PLAN COMMISSION

Wednesday, March 12, 2025 – 6:30 PM

From: Administrator/Staff
 To: Plan Commission
 Re: Plan Commission review & recommendation on a Site Plan Application submitted by Wildflower Development for a proposed addition to the existing storage condominium development located on Tax ID #006-0895-06 (north of 7577 Black Top Way).

Cedar Corporation was requested to provide an engineering review for the above referenced project regarding Stormwater Management, Grading, and Erosion Control.

EROSION CONTROL PLAN MAN CAVES CLAYTON, PHASE 3

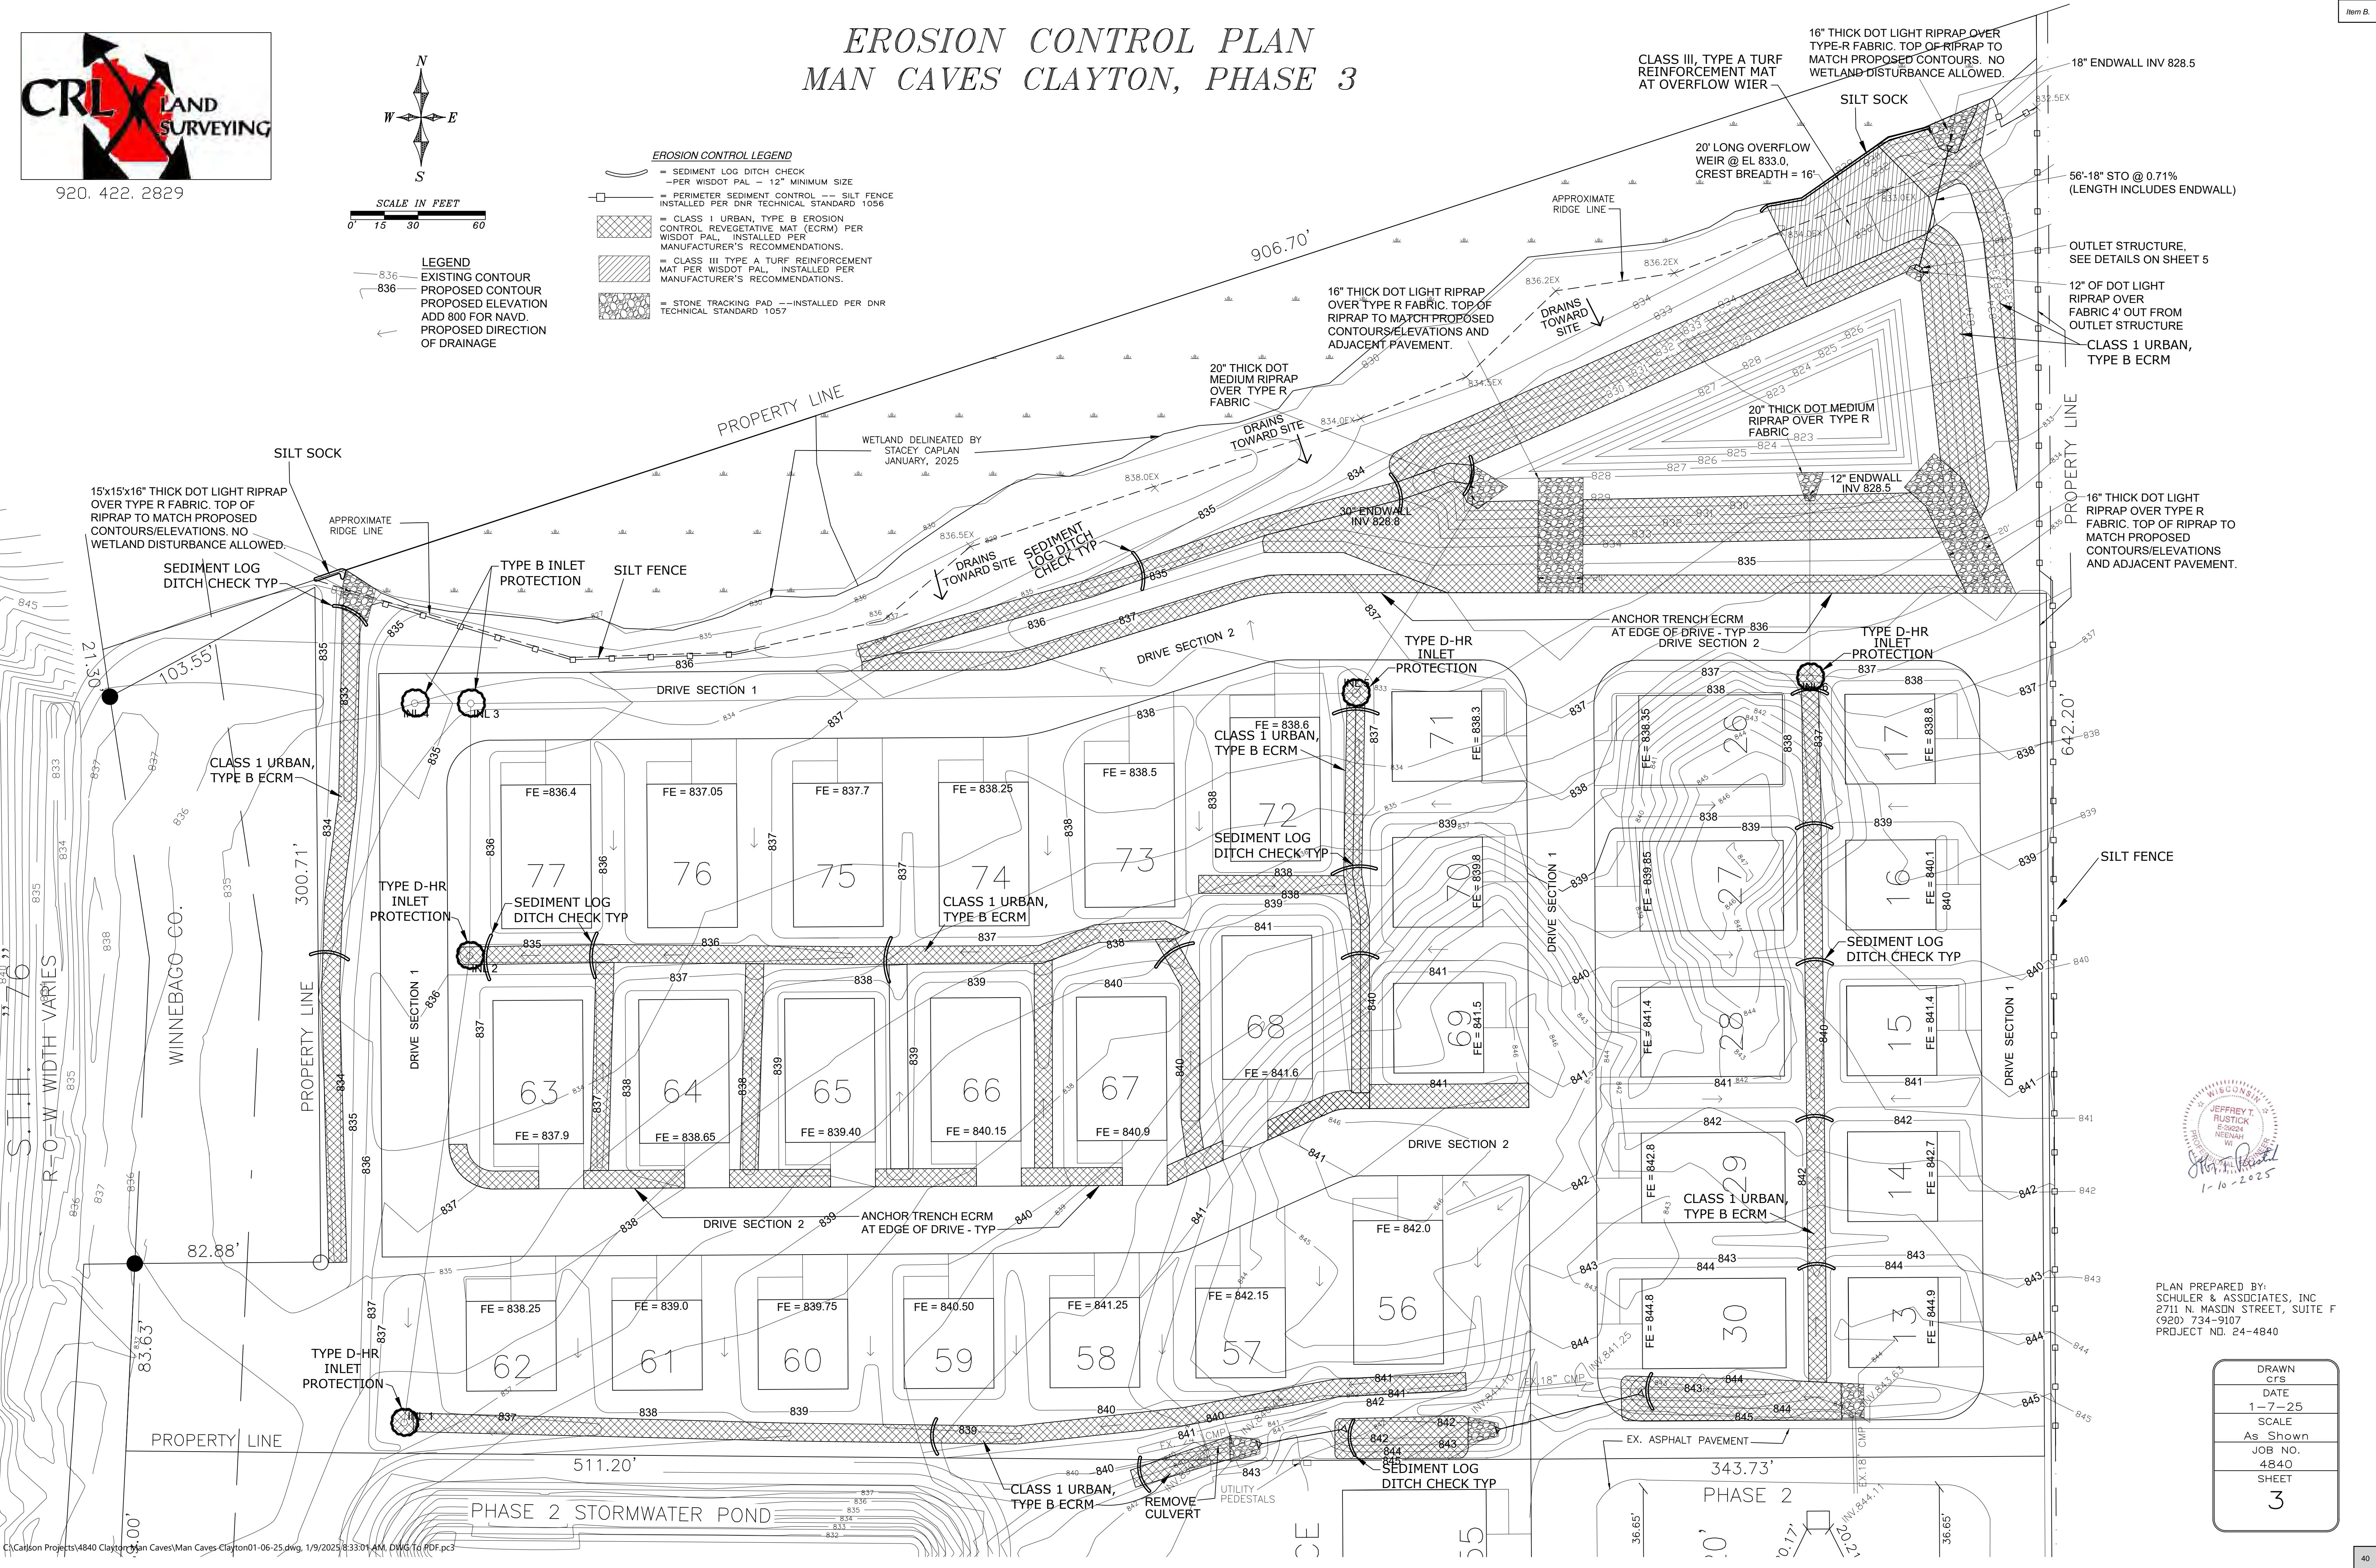
5. Plan Sheet 3 – Add the proposed tracking pad location to the plan.
6. Plan Sheet 5 – Detail 1 – Outlet Structure Details – The 18” outlet pipe invert elevation is labeled as 829.9. Revise to 828.9.
7. Storm Water Management Plan – Pipe Sizing Calculations
 - a. Inlet 5 to Endwall Pipe size is incorrect. Should be 30” pipe.
 - b. Note the Manning’s Roughness Coefficient (“n” value) that was used to calculate the pipe capacity in the Storm Sewer Design Spreadsheet.
8. Construction As-Built Drawings of the storm water management facility and outlet structure will be required to be submitted to the Town of Clayton following construction.
9. Provide a copy of the recorded maintenance agreement for Town of Clayton files.
